ADDENDUM NO. 2

Reference: New Residential Life Building
Weber State University – Ogden, Utah
DFCM Project No. 09191810

Addendum No. Two
for the
Weber State University
New Residential Life Building
DFCM Project No. 09191810
MHTN Project No. 2009566

1 LEVEL 1 MECHANICAL FLOOR PLAN - AREA "A"

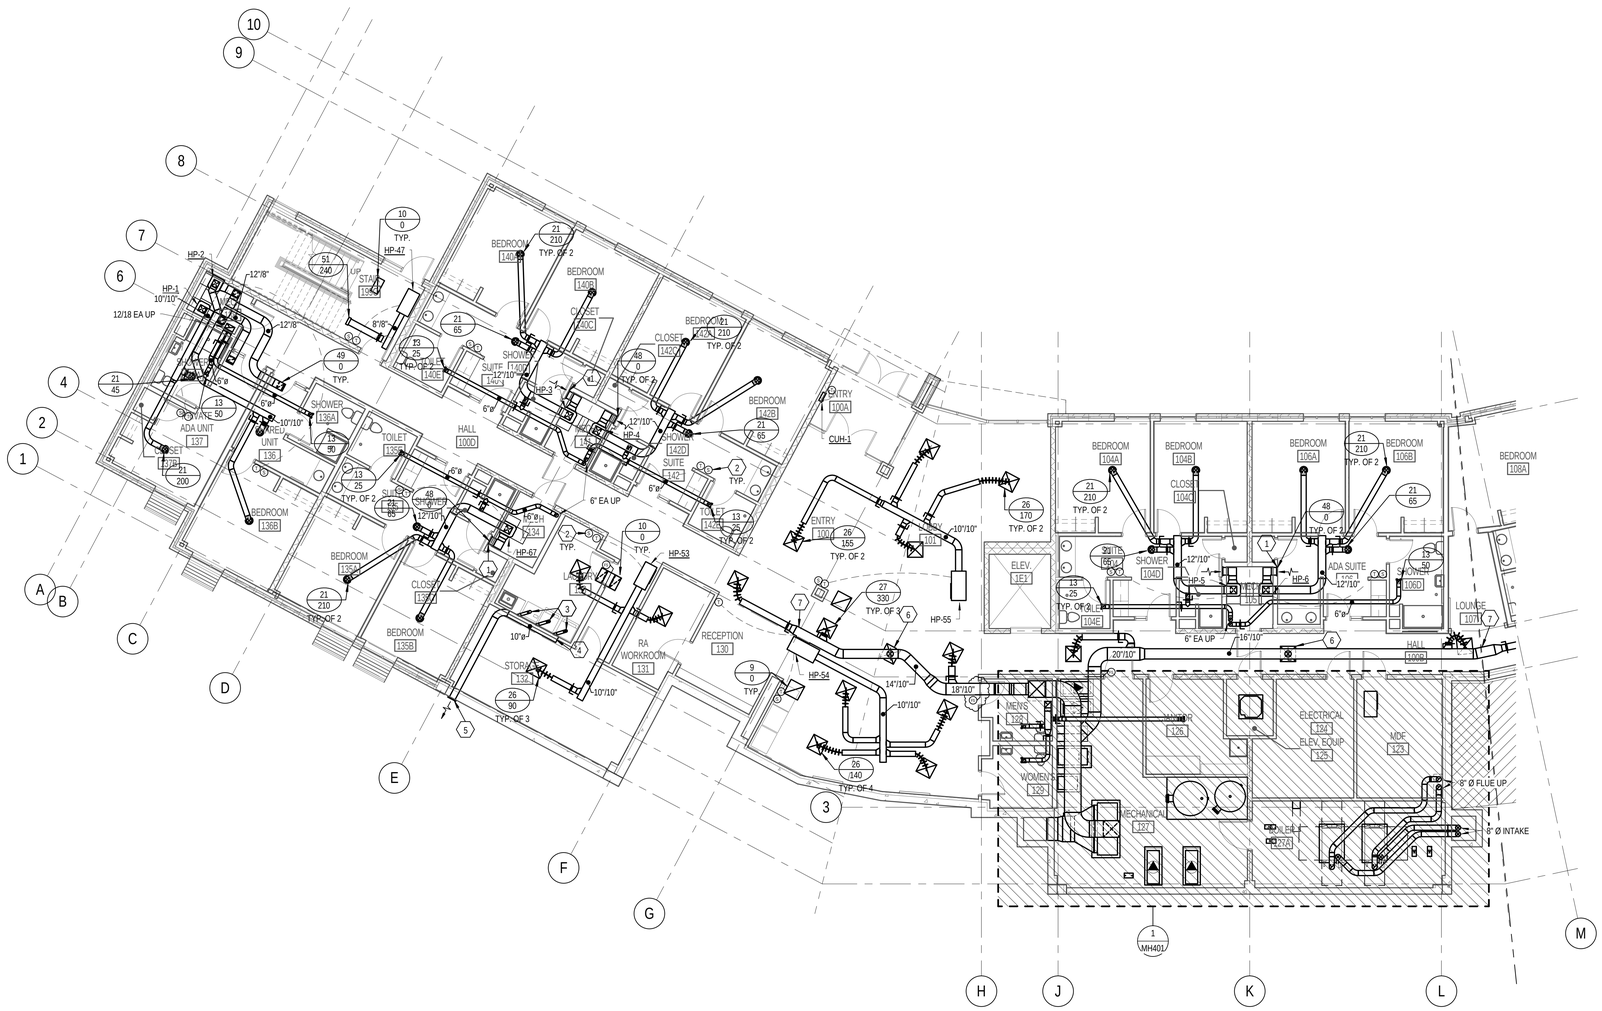
Item No.	Add, Delete or Clarify	Specification Section or Drawing No.	Reference / Description:
1	Clarify	235500	Deleted section and moved Solar Equipment to Section 224450.
2	Clarify	230900	(FMS) Facility Management System is the same system as (BMS) Building Management System.
3	Clarify	230900	1.6, Responsibility matrix, change Div. 15 to 23 & Div. 16 to 26.
4	Clarify	230900	Change all references of Butterfly Valve to Ball Valve
5	Add	MH101A	Add Fire/Smoke Damper to West Wall of Men's 128..
